Re: **Second Submission Review** – Porteos Infrastructure Site Plan (Preliminary Plat) Phase 8 – FDP Amendment and Preliminary Plat

**Application Number:** DA-1903-18  
**Case Numbers:** 2012-7001-07; 2020-6020-00

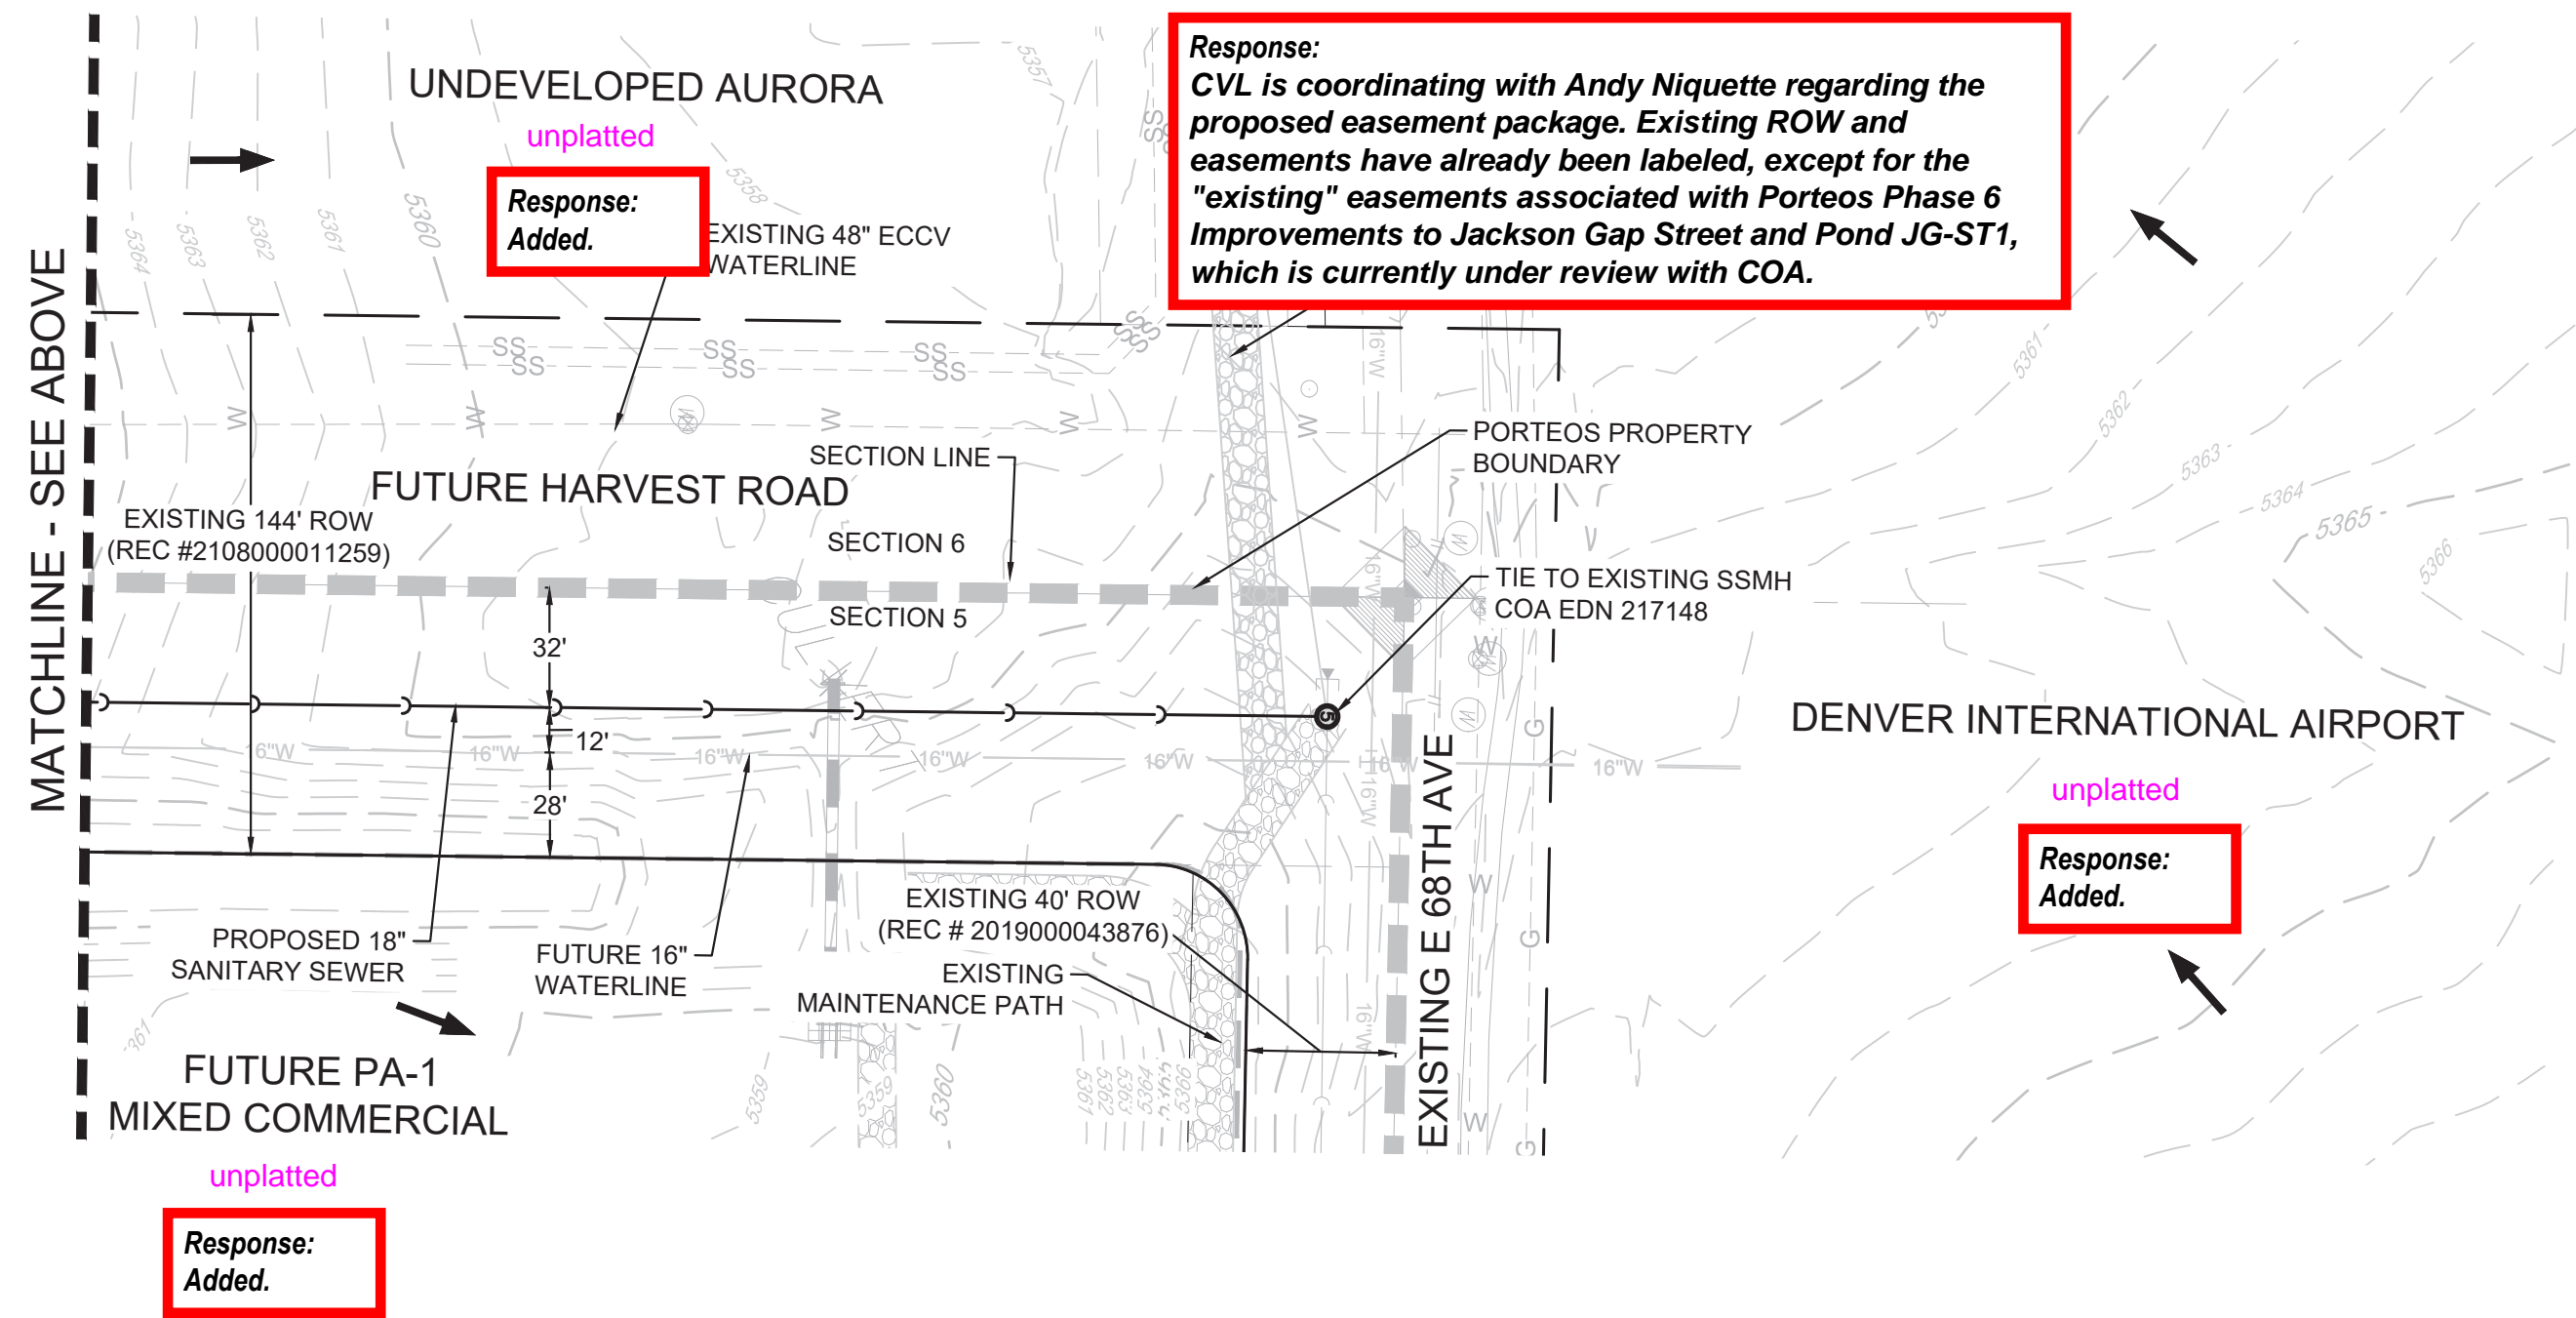
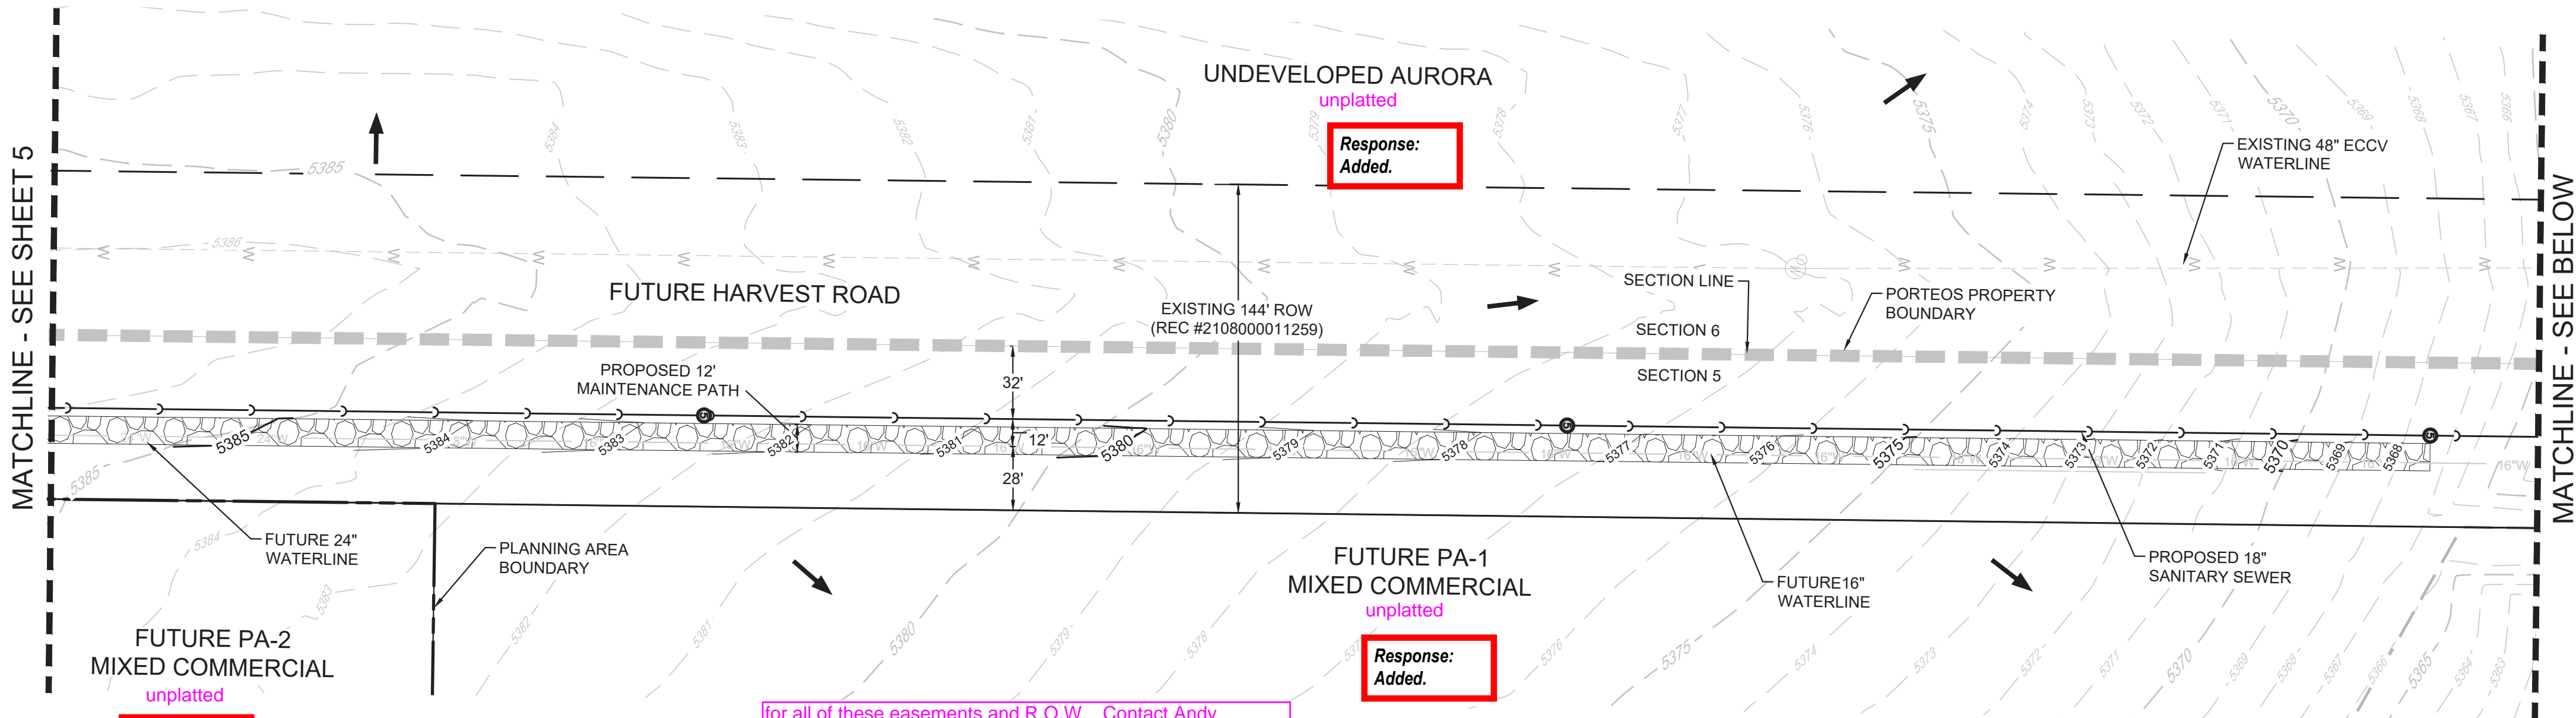
for all of these easements and R.O.W. Contact Andy Niquette by email at (aniquett@auroragov.org) to start the processes. Label the existing easements and R.O.W. with the specific reception no.

Response: CVL is coordinating with Andy Niquette regarding the proposed easement package. Existing ROW and easements have already been labeled, except for the "existing" easements associated with Porteos Phase 6 Improvements to Jackson Gap Street and Pond JG-ST1, which is currently under review with COA.
